Addendum No. 001

Subject: HVAC Renovation
General, Mechanical, & Electrical
SDP Contract No. B-105/106/107 (c)2017/18

Location: Marin Elementary School
3rd & Ontario Streets
Philadelphia PA 19140

This Addendum, dated February 16, 2018, shall modify and become part of the Contract Documents for the work of this project. Any items not mentioned herein, or affected by, shall be performed strictly in accordance with the original documents.

A-001.1	DRAWING NO.
	SPEC NO.
	SCALE 1/8"=1'-0"
	DATE 02/15/18

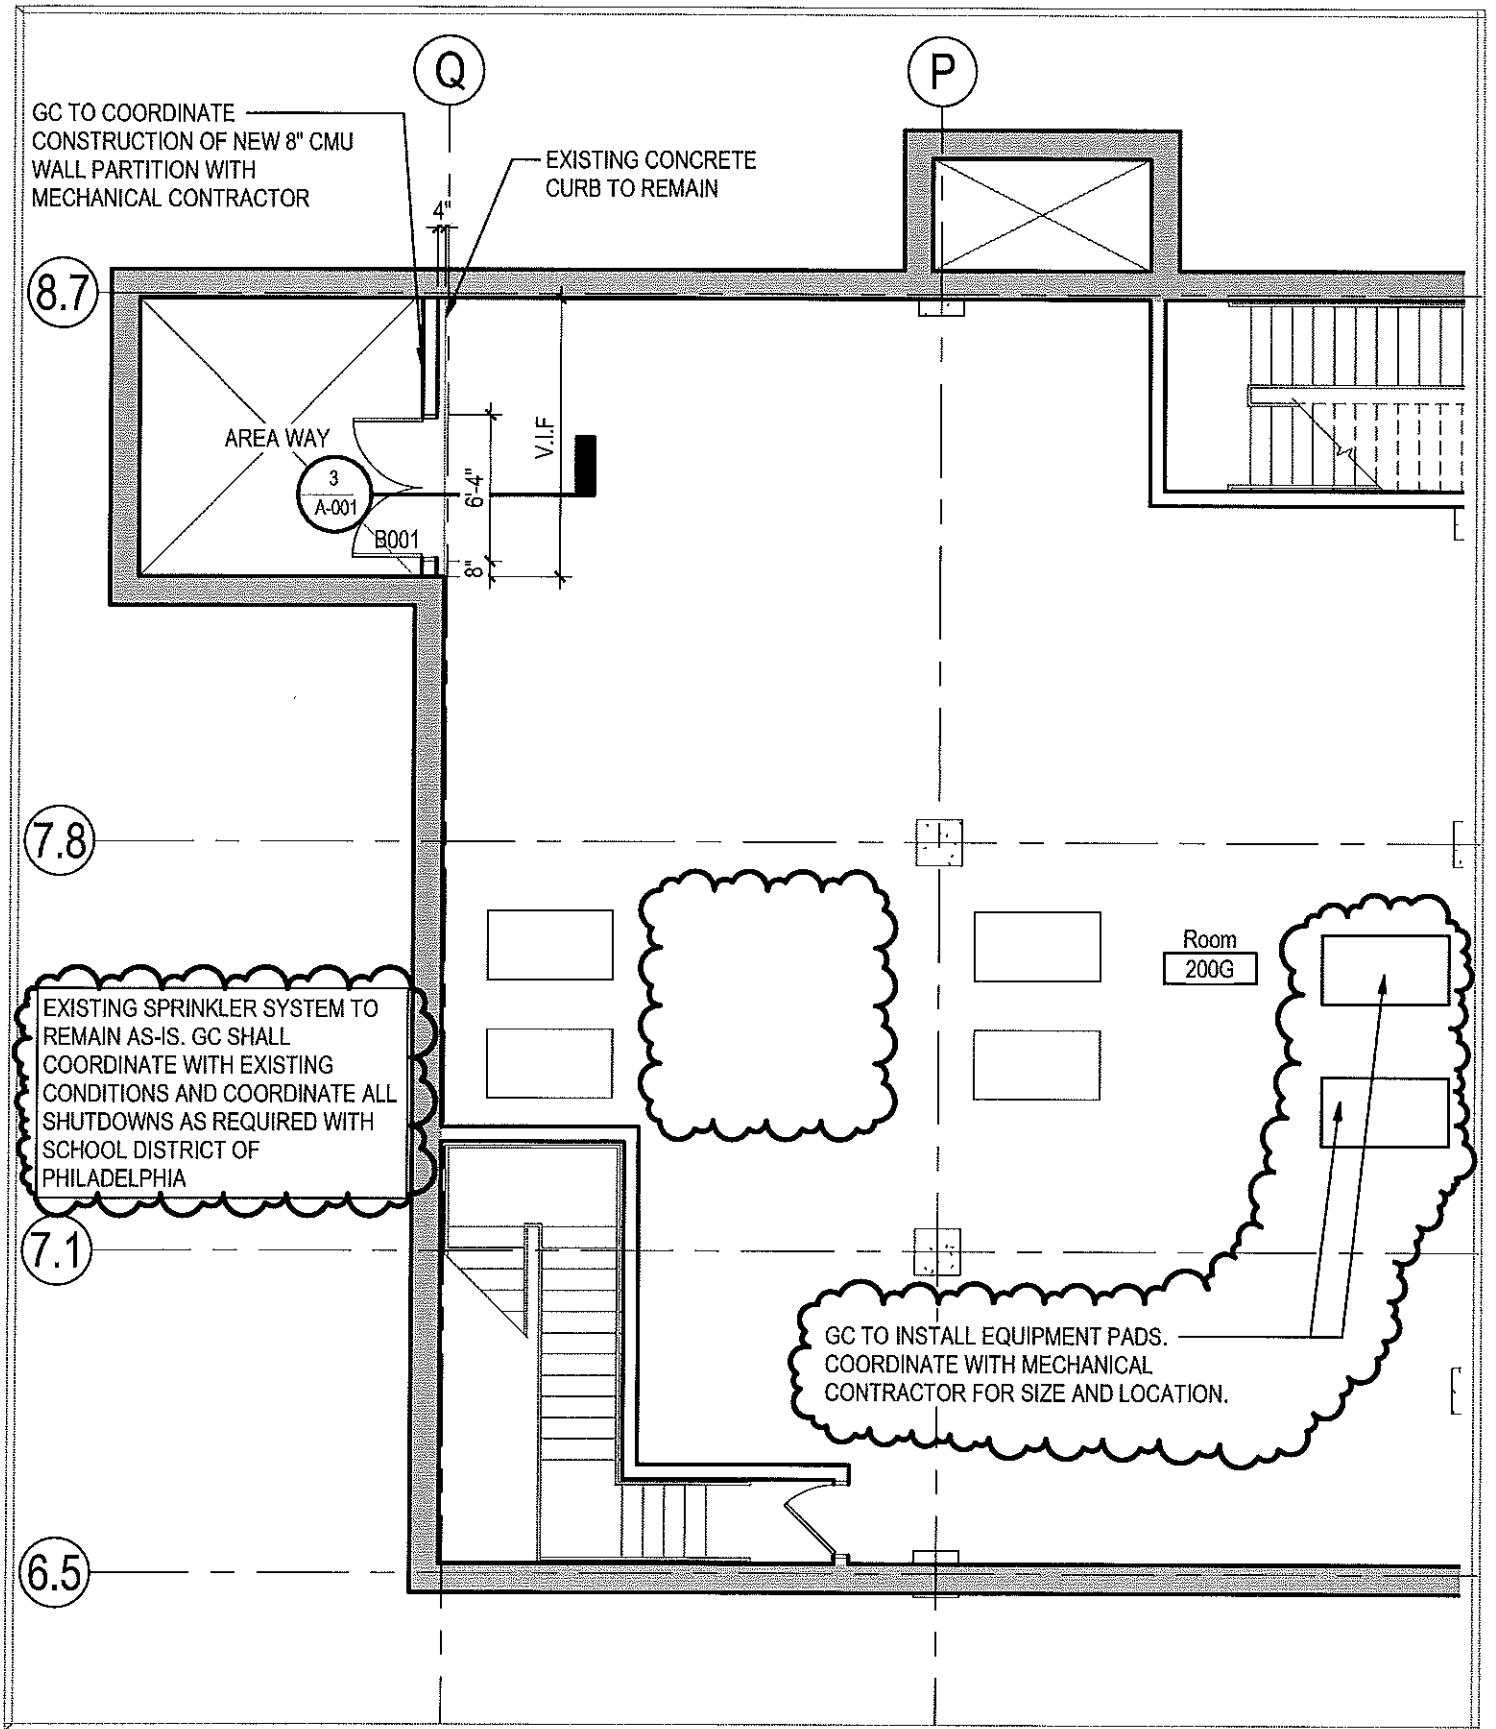
- 3.1** Drawing A-001 – Notes for demo equipment pads and coordination with mechanical have been added. Refer to attached sketch A-001.1 referencing mechanical drawings.
- 3.2** Drawing M-204 – Pipe insulation has been clarified to show that it shall be included from mechanical room to point of chiller connection. Refer to attached sketch M-204.2, referencing Note 5 on M-602. All new piping to be primed, top coated, and insulated.
- 3.3** Refer to sketches M-601.1 and M-602.1 for information regarding specification of glycol and the % required for the system.
- 3.4** The sprinkler system throughout the existing elementary school is to remain in place. General contractor to coordinate any required head relocations or shutdowns as required by the Mechanical Contractor with School District of Philadelphia. Refer to sketch A-001.1 for added note.

M-602.1a

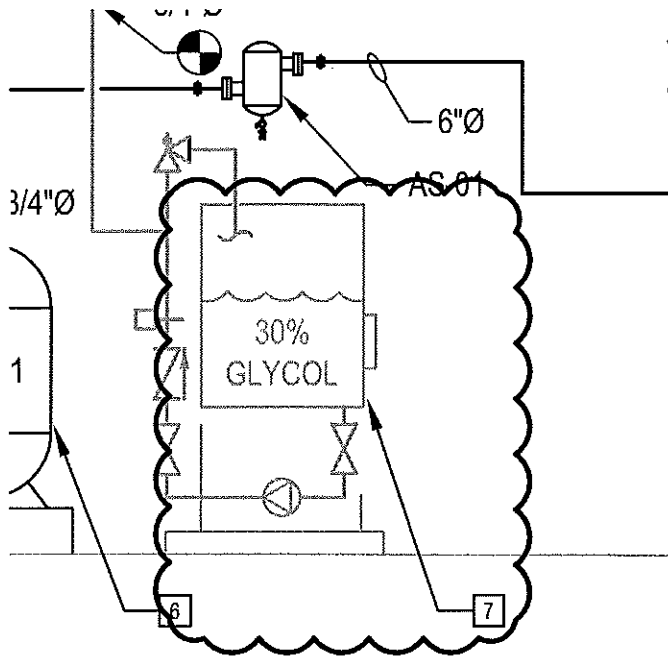
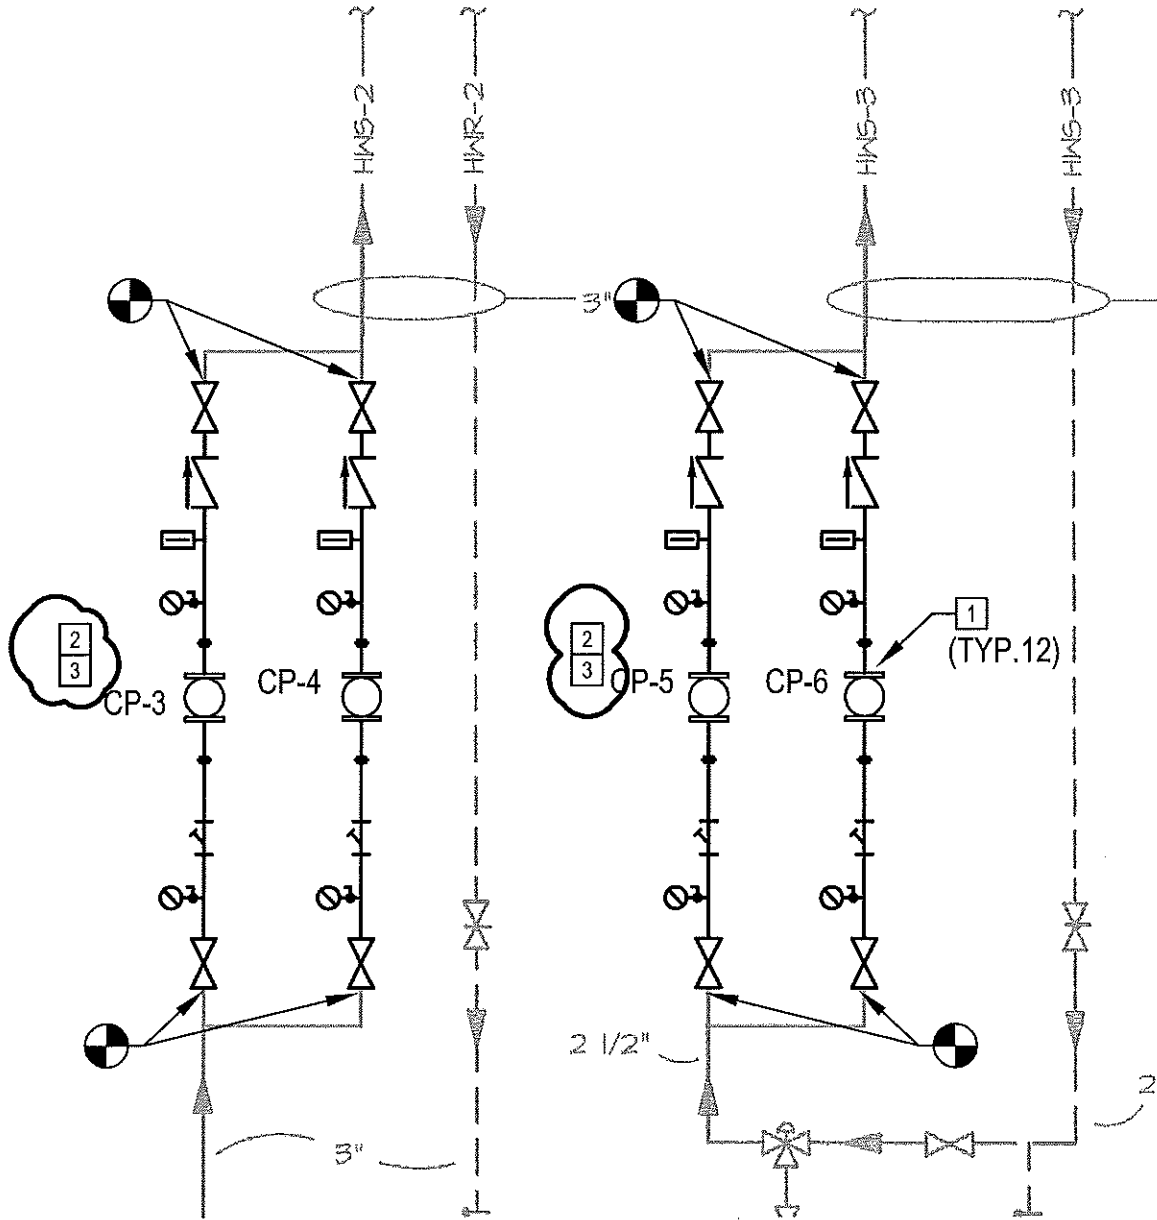
- 2.6** The control valves in the basement are not indicated for replacement. How are these valves addressed?
Response: Refer to sketches M-602.1, M-602.2, M-602.3 & M-602.4.

- 3.9 M-100 – Note 3 has been removed in its entirety from this page.
- 3.10 Drawing M-602 has been modified – V1, V2, V3, and V4 – Remove and replace with new manual wheel valves and chain operators. Valve V9 – Remove and replace with 2 manual valves and chain operators. Refer to sketches M-602.1, M-602.2, M-602.3 & M-602.4 for additional information.

- 3.11 Drawing M-602 has been modified–Note has been added to remove control valves V1, V2, V3, and V4 as well as 3-way valve V9 located above pumps 13 and 14. Replace 3-way control valve with 2 manual wheel valves with chain operators. These have been identified with bold text on the drawing. Refer to sketches M-602.1, M-602.2, M-602.3 & M-602.4 for additional information.

E-102.1

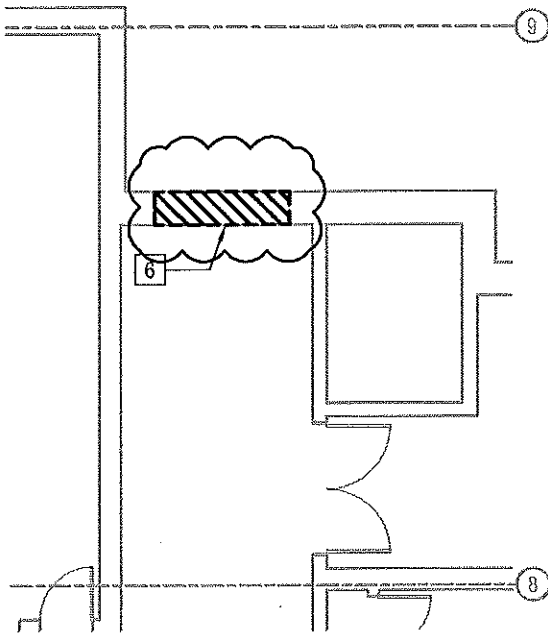
- 3.8 Drawing E-102 – Note 6 has been revised to coordinate with temporary work note 4 on the AD drawings. Refer to sketch E-102.1 for additional information.

E-202A.1
DRAWING NO.

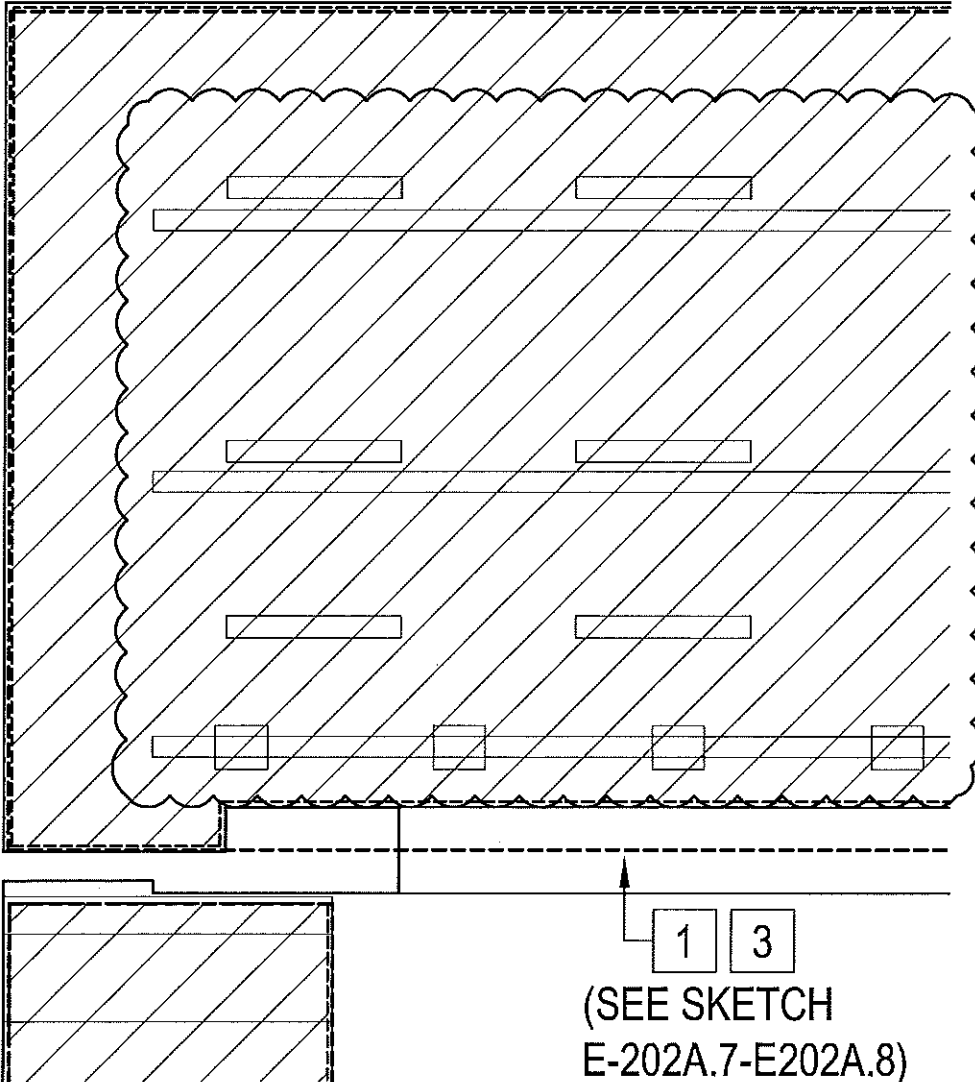
- 2.1** Are the three forty foot rows of border lights and eight industrial light on the stage mounted under the ductwork to be removed and reinstalled?

Response: Yes. Refer to sketches E-202A.1 thru E-202A.8 for light locations and notes.
- 2.2** Are we responsible to replace the 120 par flood lamps in the border fixtures?

E-302.1
DRAWING NO.

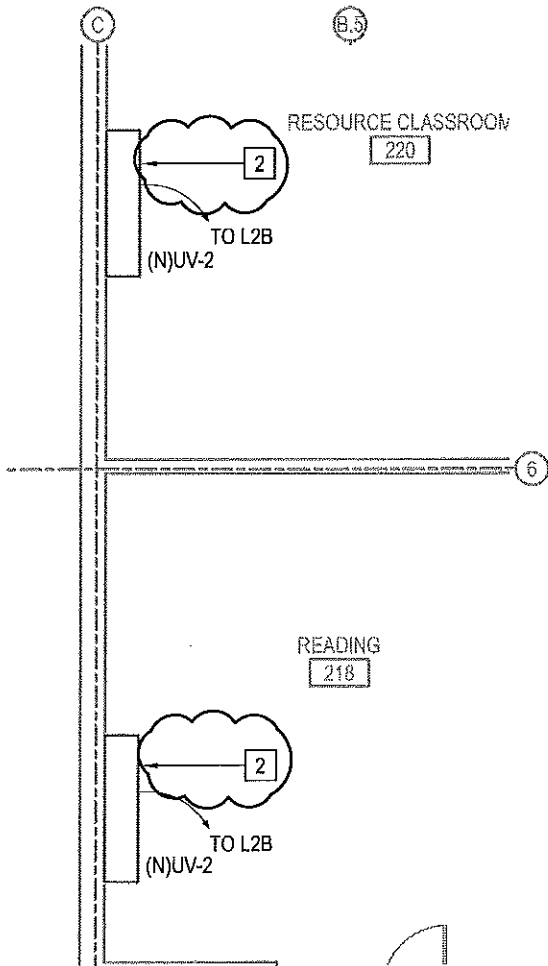
Response: Yes. Refer to sketches E-202A.1 thru E-202A.8 for light locations and notes.
- 2.3** Drawing E-302A shows keynote #3 pointing at some of the the unit ventilators Please confirm if this is incorrect and should be keynote #2.

Response: That is correct, and those keynote numbers will be changed to #2. Refer to sketch E-302.1 for revised information.
- 2.4** Drawing E-303 shows keynote #3 pointing at some of the the unit ventilators Please confirm if this is incorrect and should be keynote #2
